SERVICE BULLETIN

Classification: BT19-015	Reference: NTB19-102	Date: November 14, 2019
-----------------------------	-------------------------	----------------------------

2017-2019 TITAN/TITAN XD KING CAB; WIND NOISE AT 40 MPH AND ABOVE

Figure 2

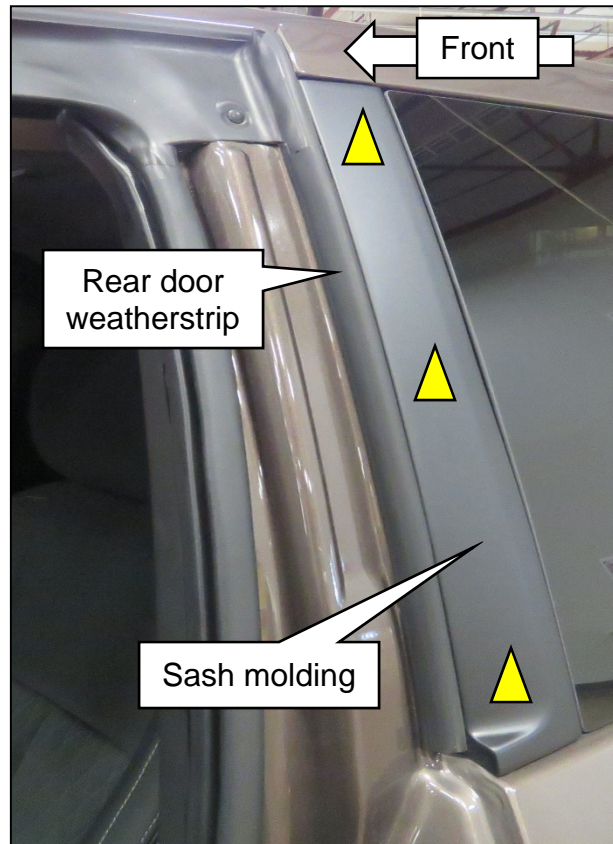
2. Partially remove the rear door weatherstrip (Figure 2).
 - Left side is shown, right side is a mirror image.
3. Release the three (3) sash molding clips, indicated with a yellow triangle in Figure 2 and remove the sash molding.
4. Replace the sash molding with the new one listed in **PARTS INFORMATION** on the next page.
5. Reattach the rear door weatherstrip.
6. Repeat steps 2 through step 5 for the right side of the vehicle.

DESCRIPTION	PART NUMBER	QUANTITY
Sash Molding LH	82287-EZ10D	1
Sash Molding RH	82286-EZ10D	1
